ZONING BOARD OF APPEALS

WEDNESDAY August 7, 2024, @ 6:30 P.M.

a. Planning Department report

JOB NO. 231562

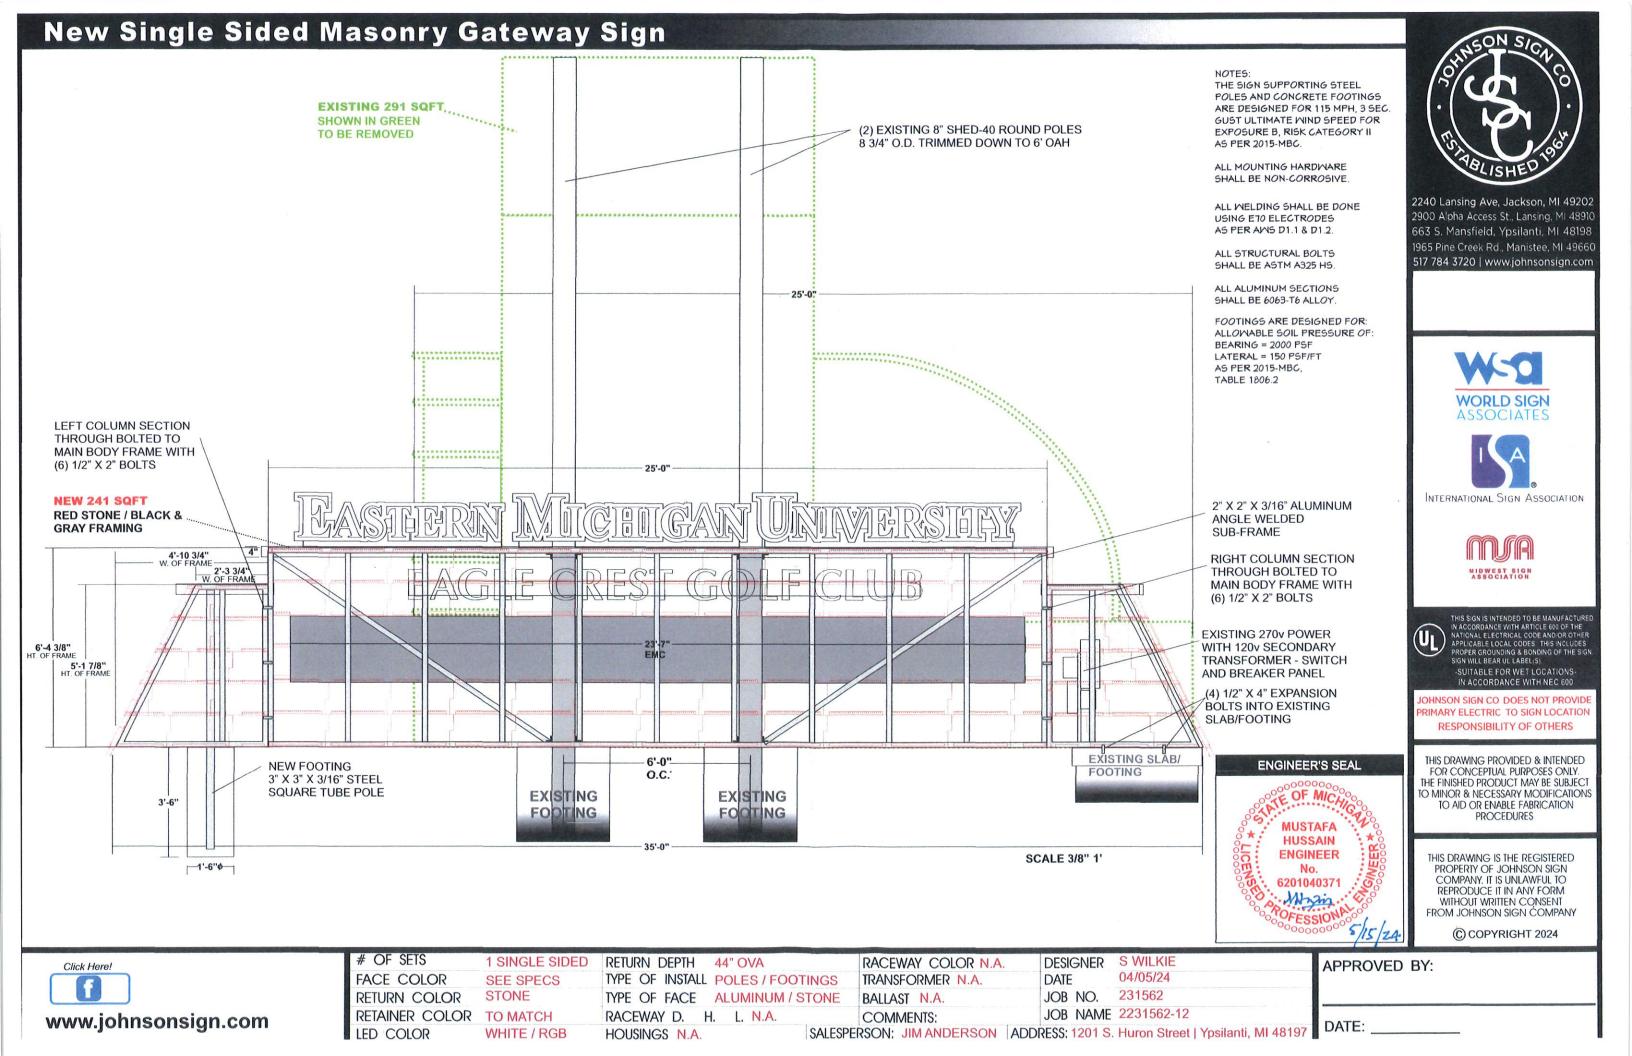
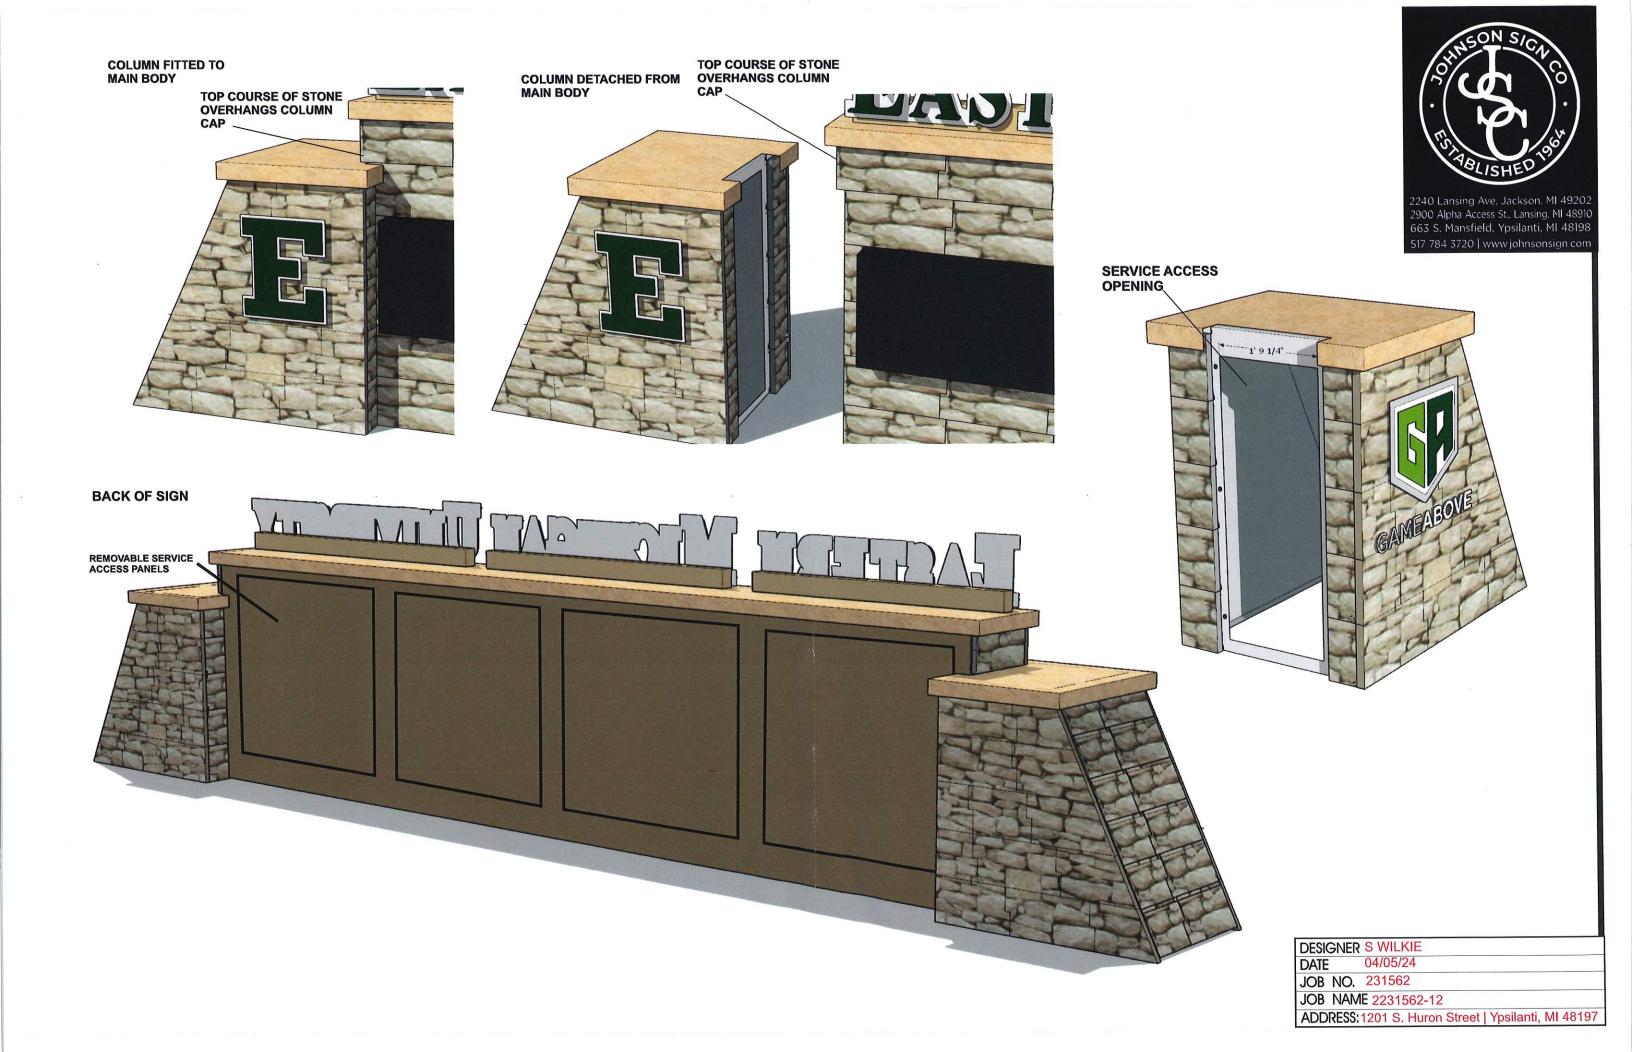
The property in question has unique characteristics that warrant the proposed variance. Specifically, the driveway entrance to the property is located at the first intersection approximately 1,000 feet south of the I-94 Highway interchange with a 45-mph speed limit. At 45-miles-per-hour, it would take less than one minute for a driver to travel this distance. This location and speed limit require signage that is easily visible to drivers who need to make relatively quick decisions due to the high-speed traffic and the proximity to the highway exit. Also, this entrance serves as a primary point of entry for visitors to this site, making effective signage crucial for safety and navigation.

Moreover, the parcel in question is very large (132 acres), with a wide frontage on Huron St. (over 1,000 feet). This condition does not generally apply to other properties in this zoning district and contributes to the uniqueness of the site.

Eagle Crest Golf Course seeks to remove their existing 291 square foot, 21' tall sign and erect in its place a 241 square foot and 8' overall height sign that emulates the Marriott sign on the opposite side of the entrance drive. The proposed sign would exceed the ordinance by 209 square feet and 2 feet in height.

SHEET INDEX CI.Ø SITE PLAN SITE SURVEY BY NEDERVELD

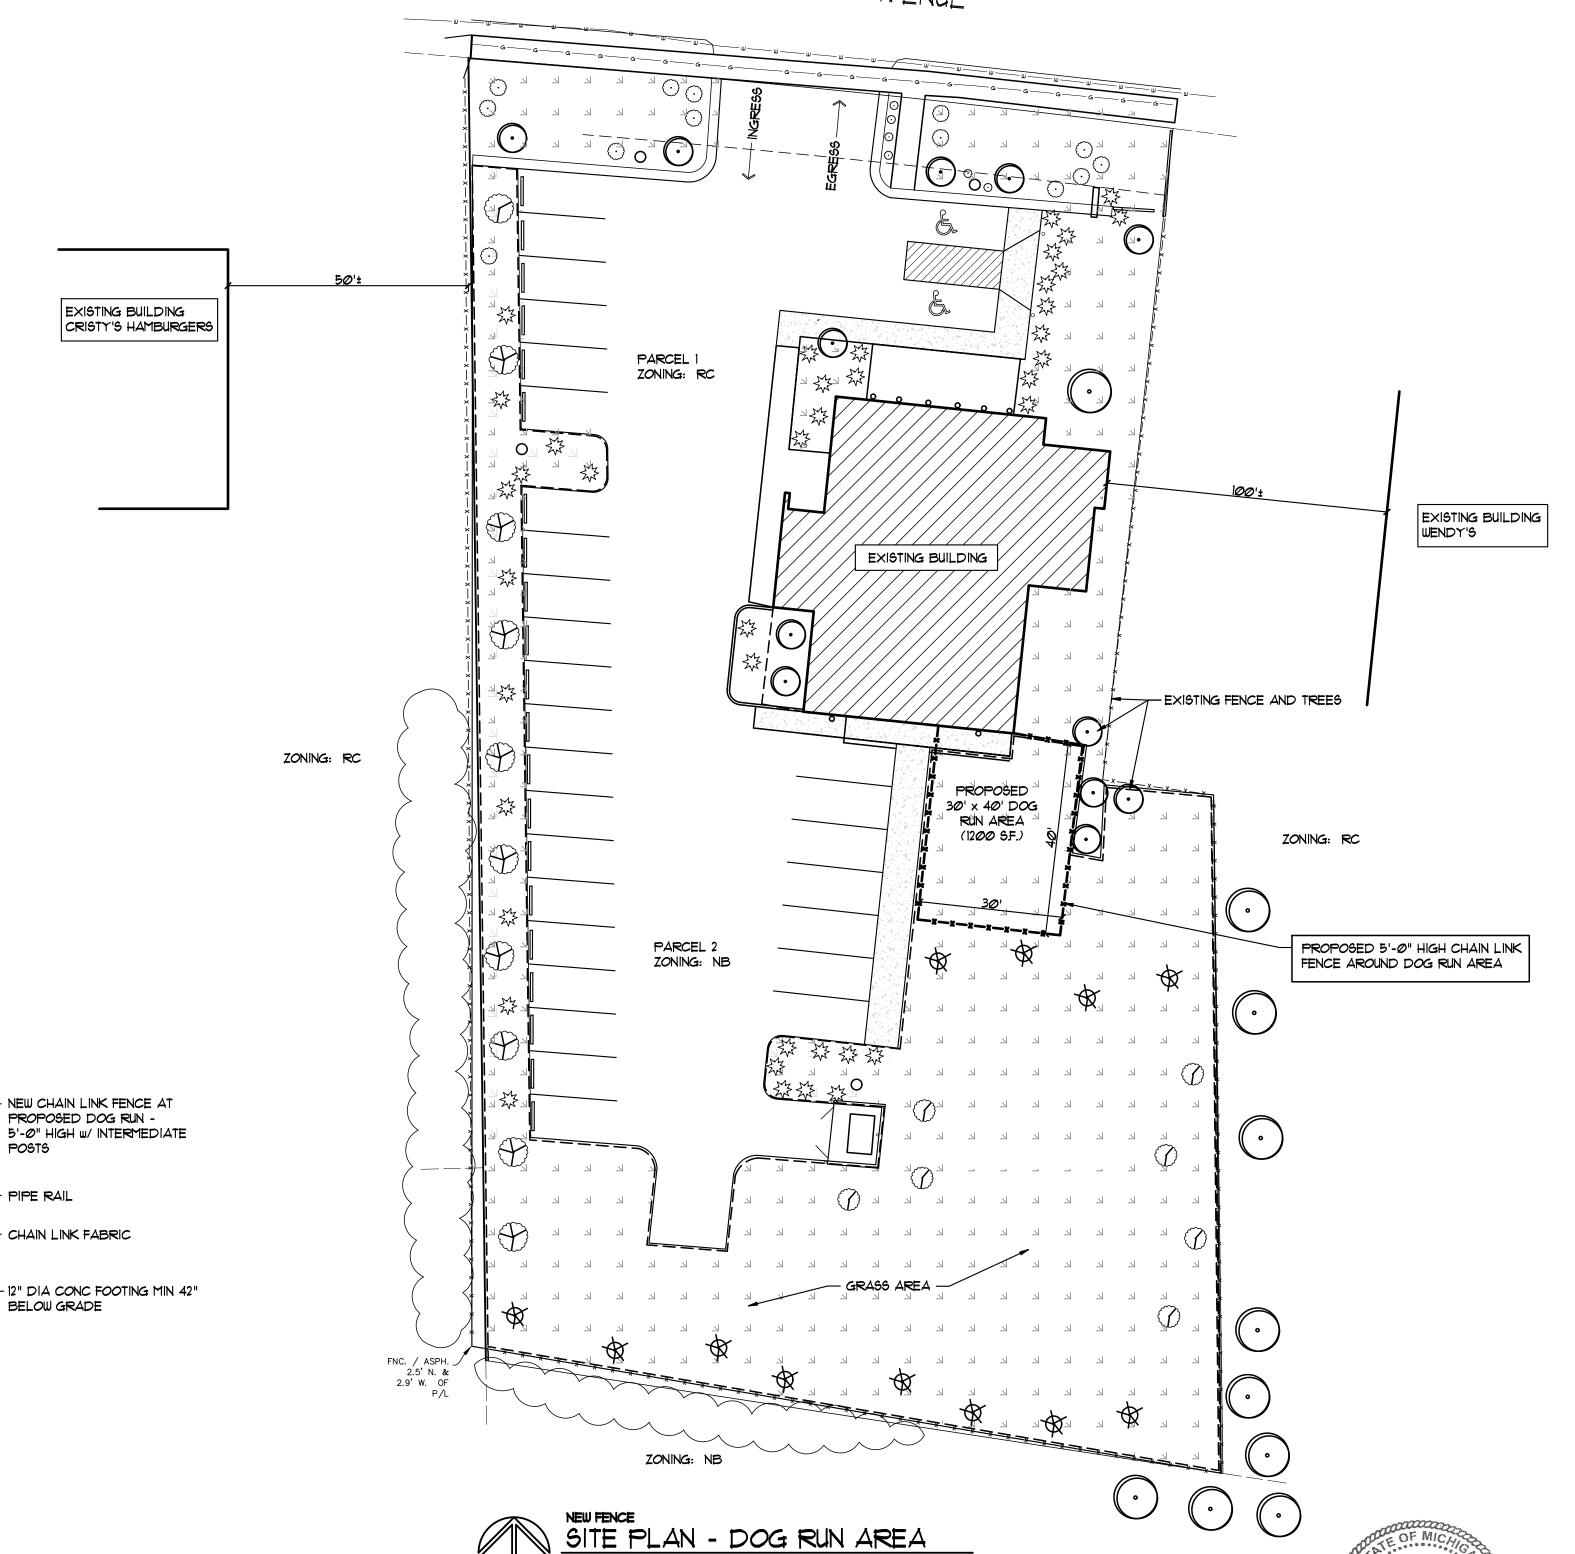
It seems that the property in question might have exceptional or extraordinary circumstances that are not generally applicable to other properties or classes of uses in the same zoning district. The nature of the veterinary clinic's operations, which includes the need for a designated area for dogs to relieve themselves, could be considered an exceptional circumstance.

It is the planning department's opinion that the proposed variance appears to be the minimum necessary to meet the operational needs of the veterinary clinic. The dog run's size and location behind the building seem to be a practical solution that minimizes impact while addressing the clinic's requirements.

The proposed fenced area will be 30' x 40' which is reduced from the area shown on the original site plan drawing. The area will allow the dogs ample space to move around safely.

EXTERIOR ELEVATIONS

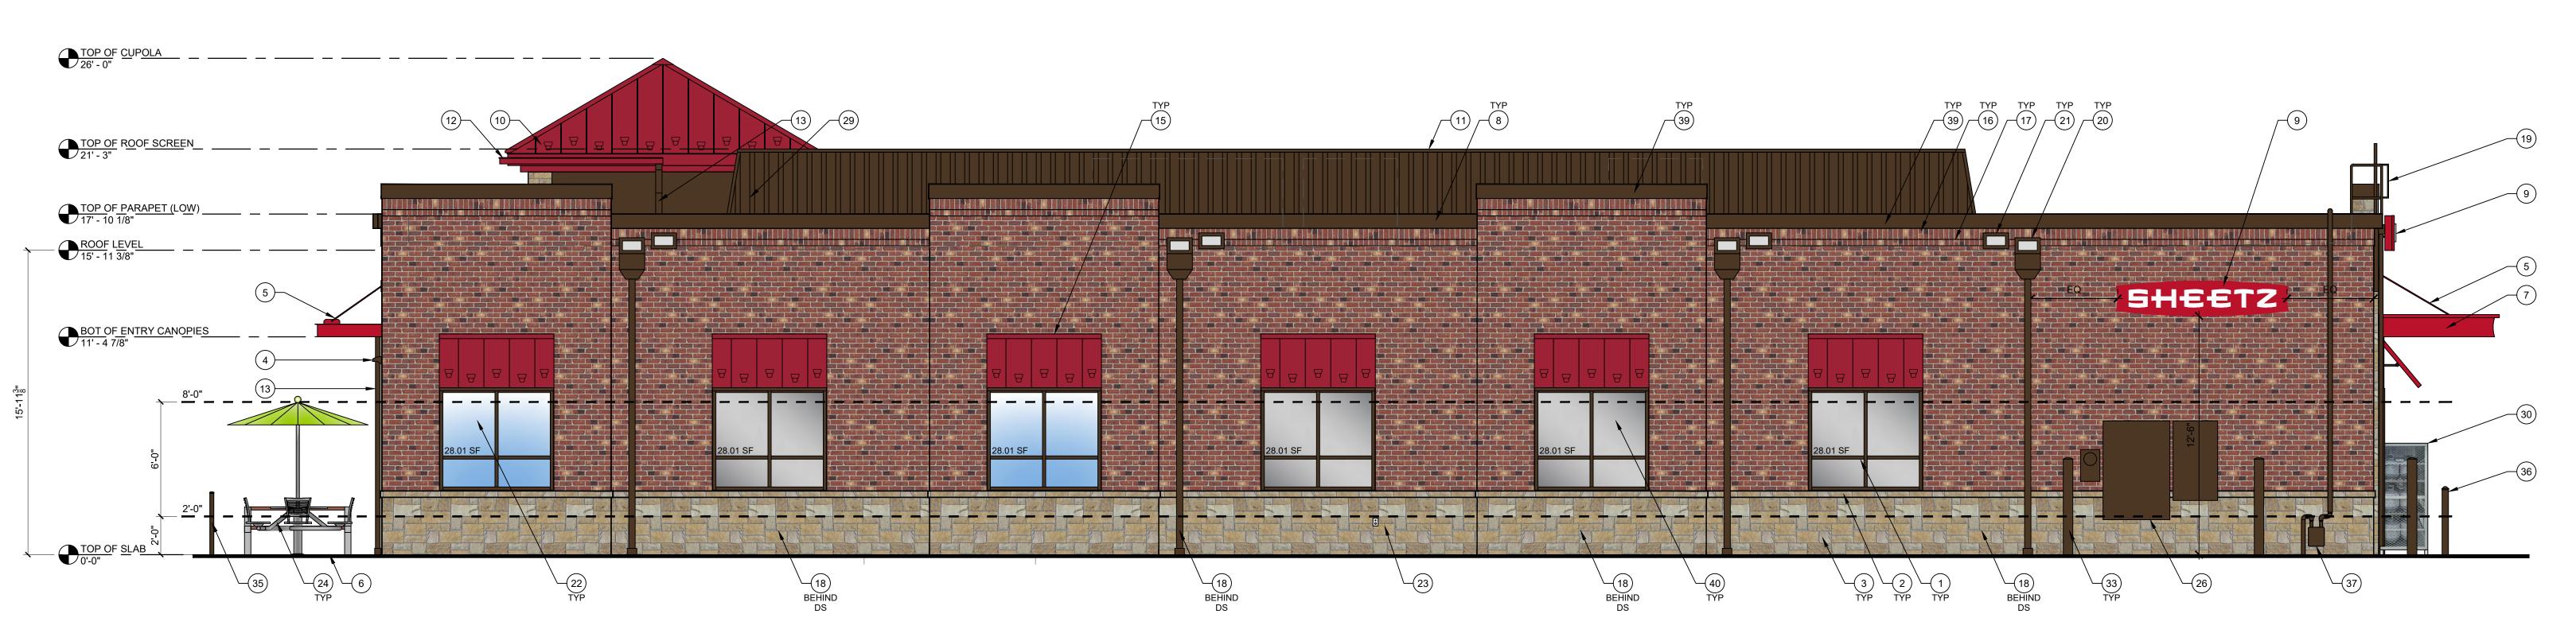
<u>W. Michigan Ave. Façade</u>. The variance for transparency on the W. Michigan Ave. facade is not necessary to preserve a substantial property right possessed by other properties. The Form-Based standards are relatively new, and existing businesses along this corridor were developed before this standard was in place. The intent of the ordinance is to establish a pedestrian-oriented corridor as new developments are established. The applicant should address the questions posed in #1 above, and also explain why the transparency requirements for the W. Michigan façade cannot be met along this street-facing frontage.

- 1) Floor plans should be provided with the variance request.
- 2) <u>W. Michigan Ave. Transparency Variance</u>. The applicant should respond to the following, and offer other options to increase the transparency on the W. Michigan Ave. façade:

- c. Has the applicant considered allowing customers to view the activity in the food preparation area?
 - d. Would it be possible to add a pedestrian door on the W. Michigan Ave. side of the building?
